THE CORPORATION OF THE CITY OF BRAMPTON

Number 88-82

To amend By-law 861, of the former Township of Chinguacousy, now in the City of Brampton. (Part of Lot 9, Concession 3, E.H.S.)

TO: The Chairman and Members of Planning Committee
FROM: Planning and Development Department
RE: Application to Amend the Official Plan
and Restricted Area By-law
Part Lot 9, Concession 3, E.H.S.
L. BRUZIO
Our File: C3E9.1

Bruzio Development
Site Plan Attachment 2

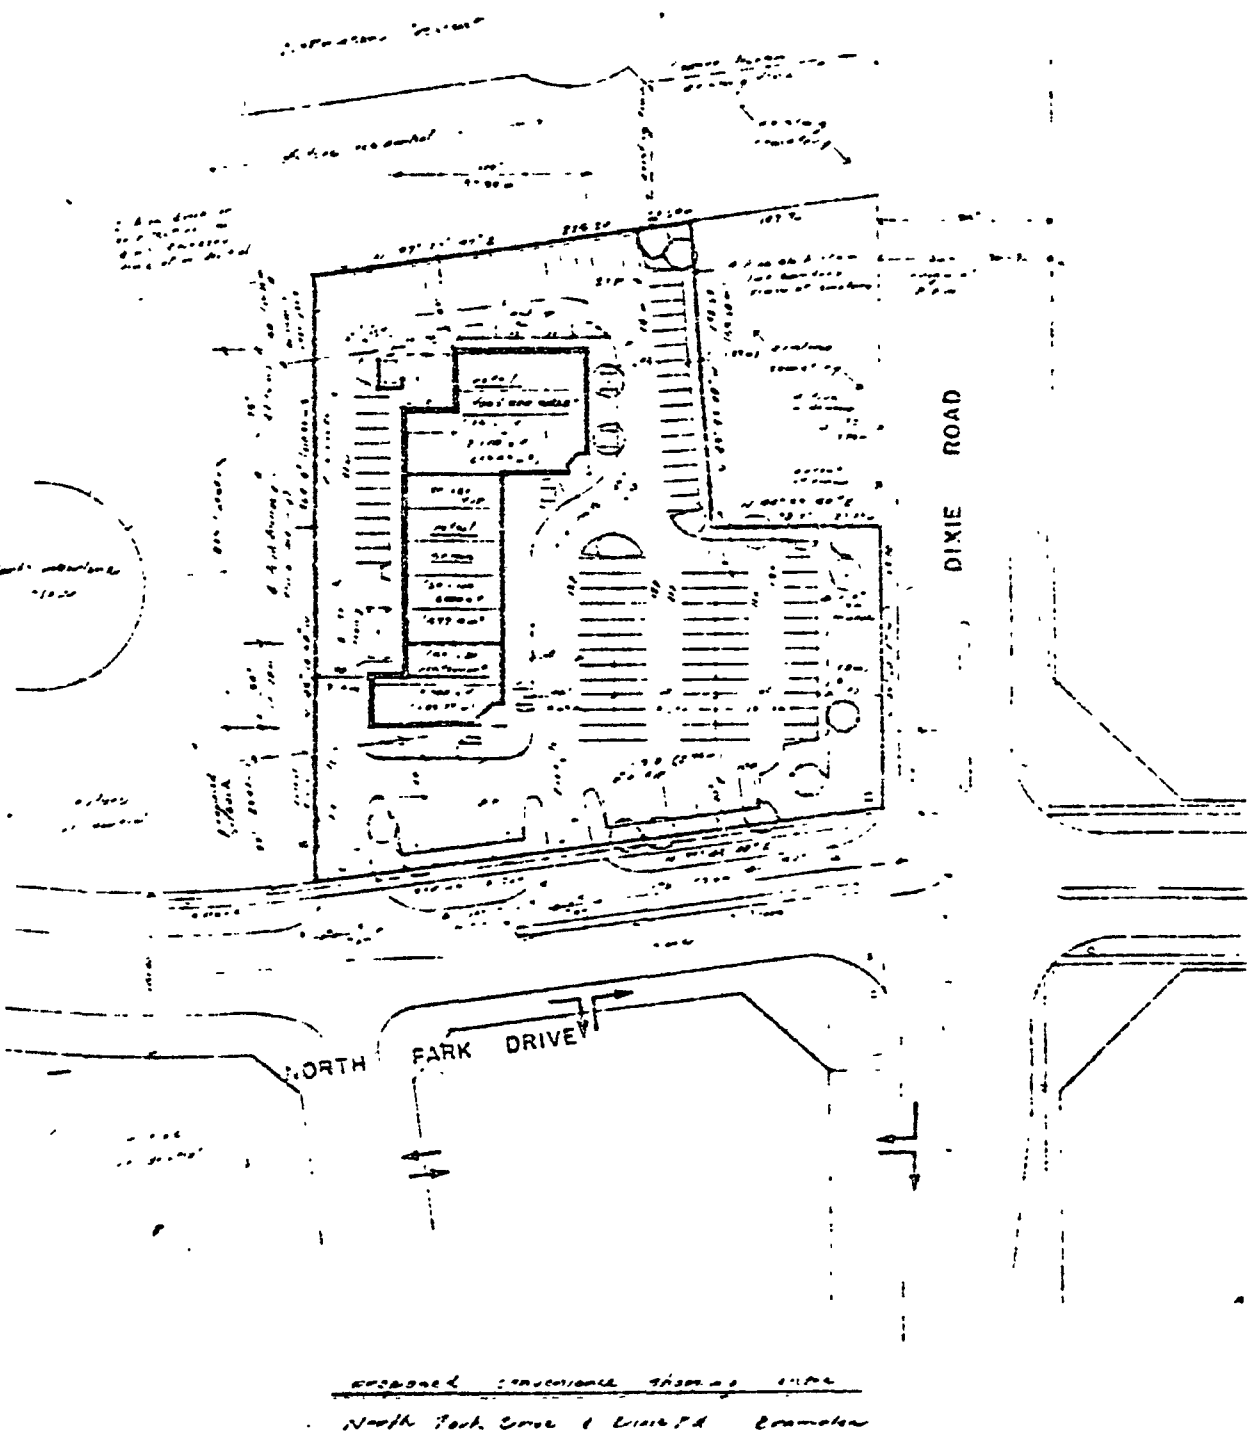
Attachment 2 to this report illustrates the latest revised submission for site development by the applicant. It is proposed as follows:

The irregularly shaped one-storey convenience commercial centre is to locate in the north-westerly portion of the 0.93ha (2.31 acre) subject site. Total building area would be 1,547.71m² (16,660 square feet). The northerly 659.59m² (7,100 sq. ft.) of the building are to be occupied by a retail food market or grocery store. The southerly

A total of 125 parking spaces are to be provided and predominantly to be located in the south-westerly portion of the site. Three loading areas are provided, one to the west and two to the north of the building. A garbage/refuse storage area has been located at the north-west corner of the building. A parcel pick-up area for two cars is located to the north of the proposed retail food market.

Two points of access are shown from North Park Drive, both being of a 7.6m (25 ft.) width. The easterly access is 53.6m (176 ft.) removed from Dixie Road intersection, whereas the westerly access is 93.2m (306 ft.) from that intersection. The distance between driveways is 32m (105 ft.). The easternmost access is to be restricted to right turns in and out only, and the existing traffic island on North Park Drive is to be extended to provide for left turning lane for 9 cars at the Dixie Road-North Park intersection.

The easterly driveway has been restricted to right turning movements only to reduce its traffic impact on North Park Drive and on the turning movements from Dixie Road. Also, that driveway has been located such as to maximize the "throat area" inside the driveway to minimize congestion on North Park Drive due to internal turning movements at nearby parking aisles.

west. The westerly access point leads directly to the rear of the building where eleven parking spaces and one loading dock are located. However, it is also possible to reach the front parking areas via this access by turning right immediately upon entering the site and passing the 8-car parking area opposite the restaurant.

It is noted that a total of 32 parking spaces are either abutting the residential lot lines or are within 30 feet from such lot lines.

Further, the garbage/refuse area is located within about 40 feet from the residential lots. Depending on wind direction and time of the year (summer season meaning increased speed of decay of fresh food wastes), odour problems may arise. It appears however, that special garbage treatment and storage facilities can be designed to minimize such problems.

- a) the plan attached hereto as attachment 2 be the basis for approval;
- b) that the zoning by-law amendment limit the uses on the site to a total gross commercial floor area of 1560m^2 ($16,800\text{ ft}^2$), permitting a grocery store of a maximum gross floor area of 659.59m^2 ($7,100\text{ sq. ft.}$); a sit-down family-type restaurant of maximum 343.73m^2 ($3,700\text{ sq. ft.}$) gross floor area, plus service shop, personal service shop, bank or trust company, an office other than medical, dental or real estate, a dry cleaning and laundry distribution centre occupying the remaining gross commercial floor area;

- g) that a 32 foot widening along Dixie Road and a 50 foot site triangle as indicated on attachment 2 be conveyed to the Region of Peel for highway purposes;

Drawing Title:
 site plan

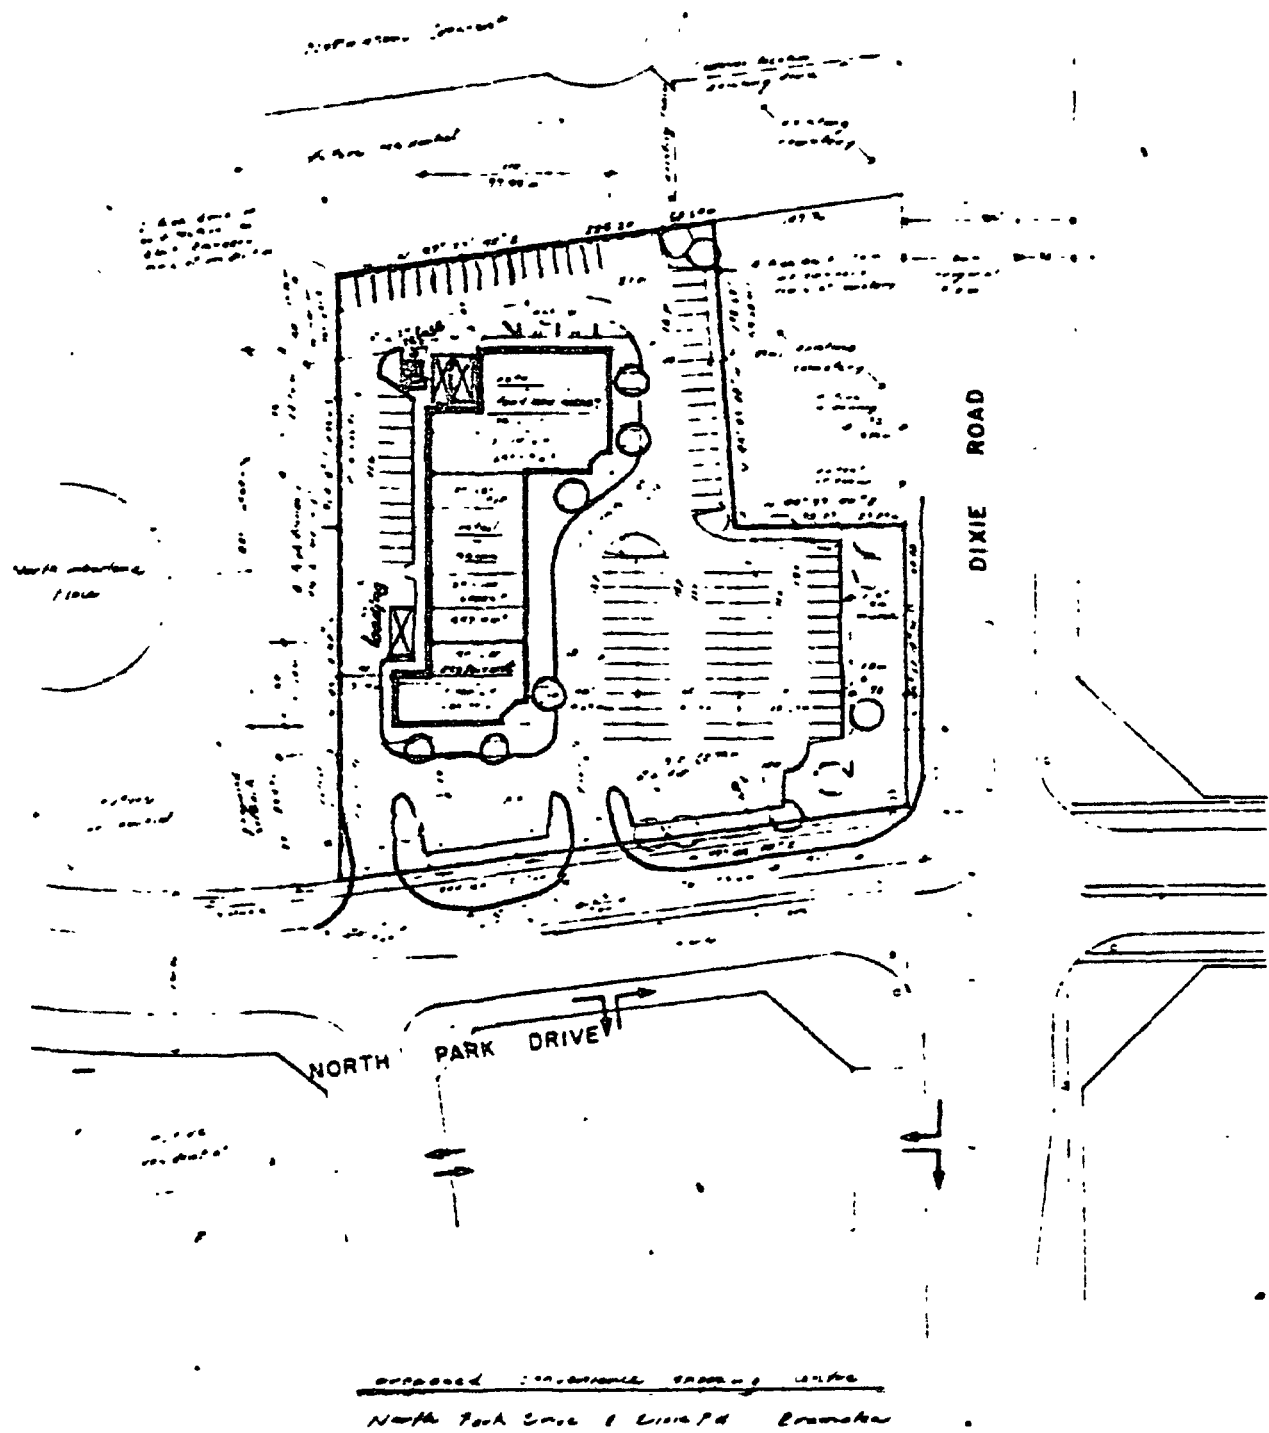
A reduced copy of the proposed revised site development plan is attached to this report as attachment No. 2 and differs from the submission previously considered by Planning Committee (see attachment No. 3) as follows:

Although the general configuration of the proposed building has been maintained, the depth of the building has been

The plan has been revised to accomodate a 139.35 square metre (1,500 square feet) retail outlet in the south-westerly corner of the building, thereby moving the proposed restaurant use further to the east-side of the building. As a result, the distance between the nearest residential rear lot line and the restaurant use has been increased from 9.14 metres (30 feet) to approximately 15.24 metres (50 feet).

The revised plan relocates the garbage facility to the north-easterly corner of the building where it would be approximately 22.86 metres (75 feet) removed from the nearest residential lot line to the north. Additional protection is to be provided by a masonry wall shielding the garbage storage facility from the north.

The revised plan shows two loading spaces, one at the rear of the building, the other next to the relocated refuse storage area to the north-east of the building.

The revised plan shows a total of 135 parking spaces, i.e. an increase of 10 spaces from the previous plan. This increase in parking spaces reflects the increase in gross commercial floor area of the revised plan. For the most part, the additional spaces have been accommodated along the north-side

The proposed relocation of the refuse area from the north-west to the north-east corner of the building constitutes an improvement in that it increases the distance from nearby residential lots and reduces the number of residential lots potentially affected by odours emanating from the refuse area. As such the proposed relocation appears satisfactory.

At the above noted meeting of Council, concerns were raised about the number of parking spaces in this location and their impact on adjacent residential lots.

In order to reduce the number of parking spaces and improve the driveway traffic flow in this location, staff suggests the following changes be made to the plan:

- Reduce the building coverage to that of the previous proposal (i.e. from 17,625 square feet to 16,660 square feet). Given such reduction, a maximum of 125 parking spaces would be needed and 10 of the 12 rear area parking spaces would no longer be required. The remaining two parking spaces may be accommodated by slight re-adjustments in the present proposed parking area arrangement in front of the building, or by providing two parallel parking spaces at the rear of the building.

- The aforementioned changes would facilitate a 3 metre (9.8 feet) wide landscaped area to be provided along the westerly lot boundary. Within such landscaped area the protective masonry wall may be erected with a sufficient area remaining for landscaping between the wall and the driveway.

- The building envelope should be re-adjusted slightly and shifted to the west permitting sufficient space between the westerly lot line and the building to accommodate the 9.8 feet wide landscaped area, a minimum 24 feet wide driveway and parallel parking spaces, if necessary, plus the presently proposed loading area. The presently shown walkway along the rear of the building would no longer be required as the elimination of most of the public parking at the rear would also reduce pedestrian traffic in that area.

- A slight shift of the building to the south (i.e. by 3m or 9.8 feet) would permit the landscaped area along the inside of the protective wall to extend parallel to the northerly boundary.

a) the plan attached hereto as attachment 2 be the basis for approval, but be modified in accordance with staff's suggestions outlined under Section 3.0 above;
